APPENDIX B – FIELD VARIANCE FORMS

FIELD VARIANCE FORM

DATE:	04-27-10	PROJECT NAME:	RI for Ricochet MRS	PROJECT LOCATION:	State Game Lands 211, Pennsylvania
APPLICABLE DOCUMENT/SECTION:	Final Work Plan, Remedial Investigation for the Ricochet Munitions Response Area (MRA), Fort Indiantown Gap, dated March, 2010 (Section 2.5 Overall RI Approach)/Subsections 2.5.1, 2.7.1, and Section 3 Field Investigation Plan/Subsections 3.3, 3.6, 3.6.1 and 3.6.3)				
SUBJECT:	Revisions to re-allocate the entire 6.2 acres of proposed DGM transects to Analog transect acres. (Note: This amendment applies only to DGM <i>Transects</i> and has no impact on the DGM <i>Grids</i> .)

DATE: <u>05-17-10</u>	PROJECT NAME: <u>RI for Ricochet MRS</u>	PROJECT LOCATION: <u>State Game Lands 211, Pennsylvania</u>
APPLICABLE DOCUMENT/SECTION:	<u>Final Work Plan, Remedial Investigation for the Ricochet Munitions Response Area (MRA), Fort Indiantown Gap, dated March, 2010 (Section 2.5 Overall RI Approach)/Subsections 2.5.1, 2.5.1.3, and Section 3 Field Investigation Plan/Subsections 3.3, 3.5, 3.6, 3.6.2 and 3.6.3)</u>	
SUBJECT:	<u>Revisions to re-allocate the acreage proposed for eight remaining DGM grids to Analog tr

DGM Grid Progress

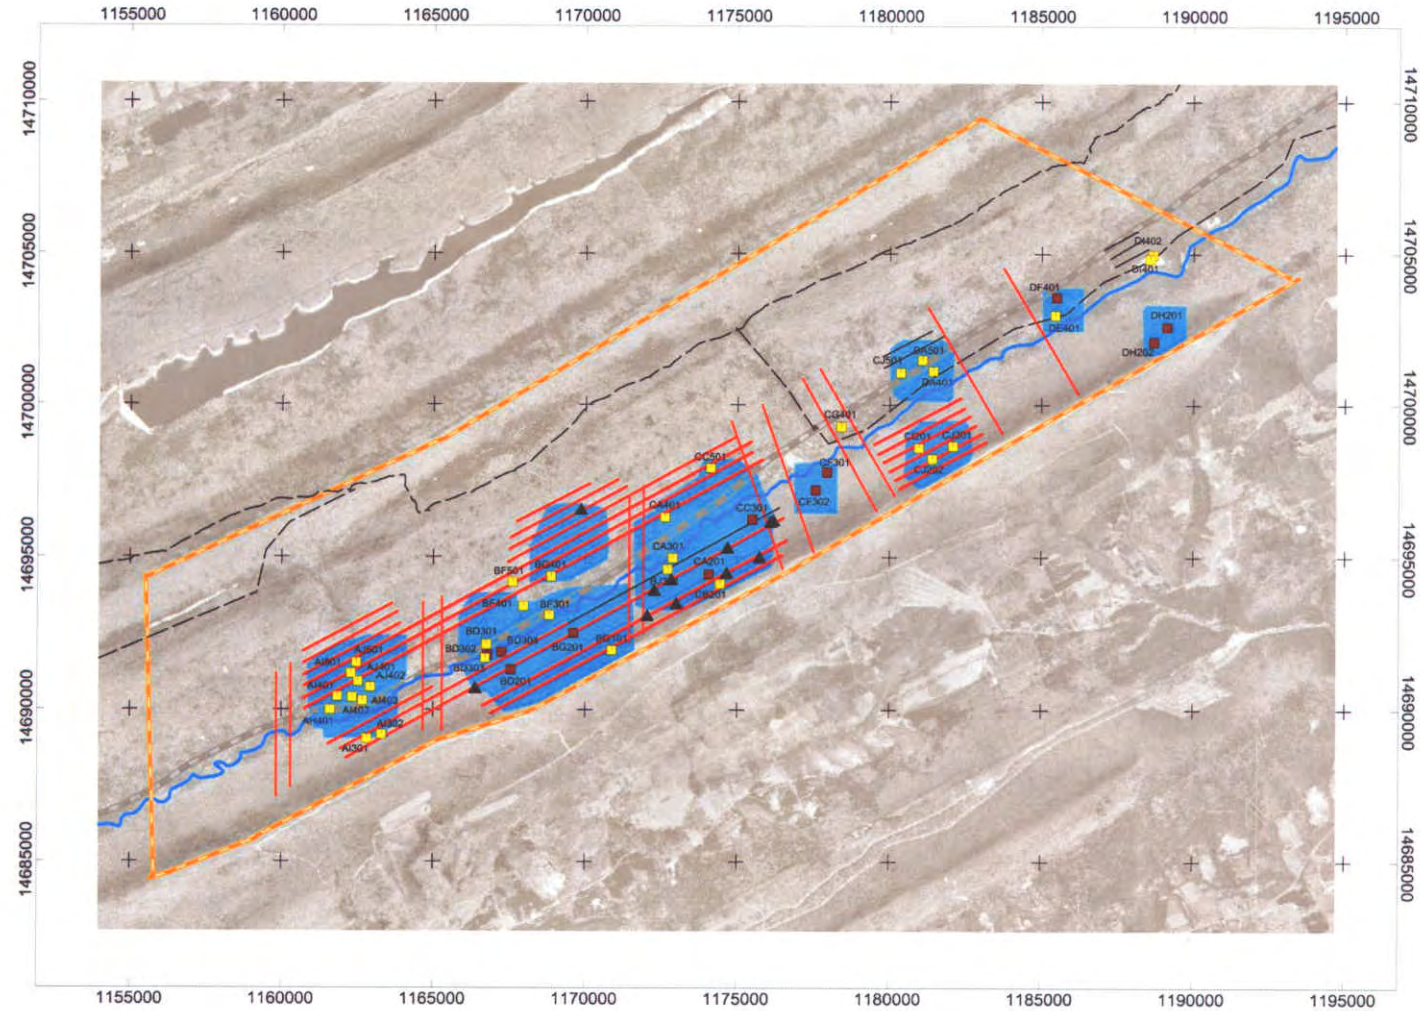
- The additional Analog Transects (shown in the attachment) will be performed across those areas possessing the highest number of targets based on the data and digs acquired to date.

- Three Analog Transects will be performed across the northern portion of Area E (see attachment) to address and bound the area north of an MD find.
- Two Analog Transects will be performed to address the northern portion of the Area west of Area E (see attachment).

- In place of the seven (100-ft x 100-ft) DGM grids, Weston proposes to take the total 35,800 linear feet (6.9 miles) of DGM Grid coverage, and apply it towards Analog transects. In addition, approximately 106,000-linear feet, (or 20.1 miles) will be added.
